**STAFF REPORT: 09-10-25 REGULAR MEETING**

**APPLICATION NUMBER: HDC2025-00433**

**ADDRESS: 467 W. ALEXANDRINE**

**SCOPE: ALTER AND REHABILITATE EXISTING FOUR-STORY APARTMENT BUILDING FOR MIXED USE**

PROPOSED - SIDE / WEST ELEVATION

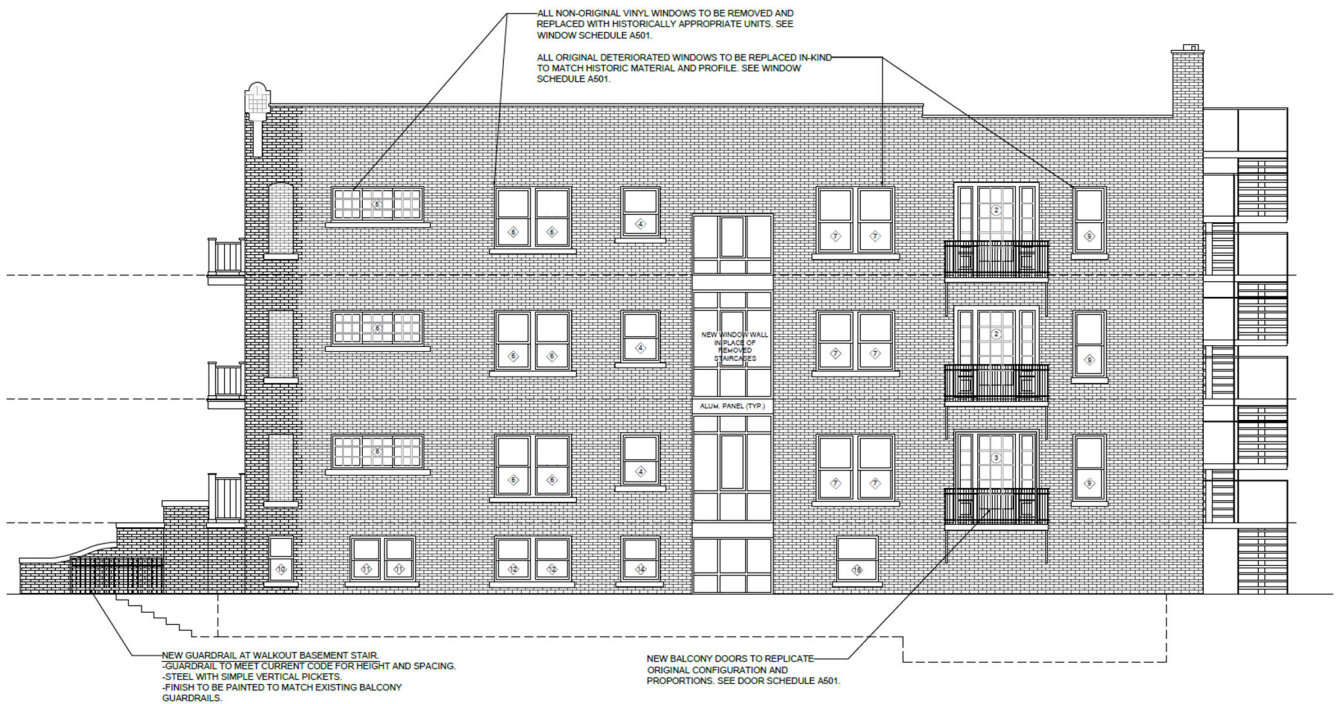
- Moreover, the architect’s choice of a glass window-wall system to “close off” these mid-building stairwell voids is conceptually useful even if some (less than distinctive) historic character was found to be lost, as the infill wall’s transparent nature, and obvious modern expression, continue to “tell the story” of the historic building, and allow the alteration to be “read” by laypeople. Staff’s assessment would be different if this was a primary façade and the stairwells were ornamented, used high quality brick, or were somehow more spatially and distinctively critical to the building’s historic character and architectural design.

- Along with the wood window/door systems still extant on the side, ornamental wrought-iron or steel brackets are still extant supporting the steel platforms projecting out at these locations. Staff is not satisfied that the applicant has demonstrated that the brackets themselves are beyond repair. While the applicant proposes to reproduce the brackets, staff recommends that the originals be cleaned, refinished and refitted for use.

- The six (6) surviving wood window/door systems (15-lite doors flanked by 3-lite windows, and all associated trim/elements) at the rear sides be preserved, repaired, and retained, as they do not appear to be beyond reasonable repair and they provide important historic character. Additionally they may serve as a guideline for restoration of the lost front-facing balcony entrances at the primary facade.

- The ornamental steel or wrought-iron brackets supporting the steel balconies and other elements at the sides be retained, repaired, and refitted, as they do not appear to be beyond reasonable repair and they provide important historic character.

PROPOSED - FRONT / NORTH ELEVATION

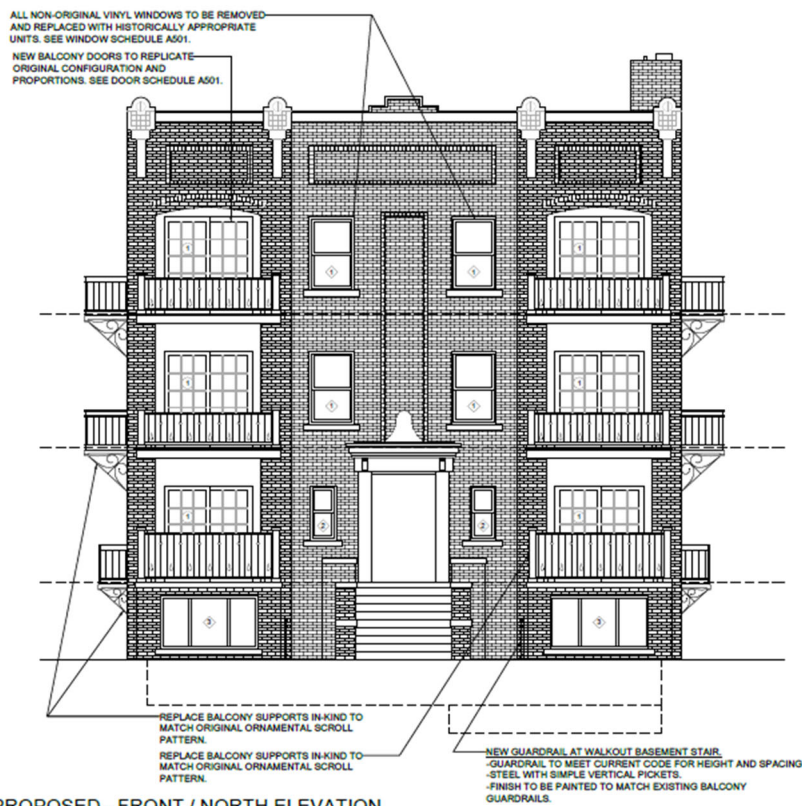
- The two lowest balcony enclosures, per the front elevation on the drawings excerpted above, appears to accept the height created in violation and retain it. This is not appropriate. The original historically correct lower height and expression must be recreated, in wood, with a booster rail if necessary/desirable hidden behind it.

- Sliding doors at the front-facing balcony/unit locations are incompatible with a pre-war building, which would have incorporated either a single-swing door flanked with sidelites, or a double set of “French” doors at these locations. It is possible that the original design was similar to the historic wood entries surviving on the side elevation balconies (i.e., a single-swing door flanked by sidelites).

- The individual unit entries at the front balconies/units be revised to incorporate historically compatible doors featuring either a single-swing door flanked with sidelites, or a double set of “French”-style doors at these locations, rather than the sliding doors as proposed, such revised design approvable by staff.

- The six (6) balcony enclosures/wooden jigsawn balustrades at the primary façade must be retained and repaired at their original historic height on all sides. The two (2) lowest level balustrades, removed and replaced in violation of the historic ordinance with incorrect height reproductions, must be removed and replaced with a lower height, historically correct reproduction, also in wood, exactly matching the original elements. Booster rails, mounted inconspicuously behind the historic elements to provide a modern code height enclosure, can be approved by staff.
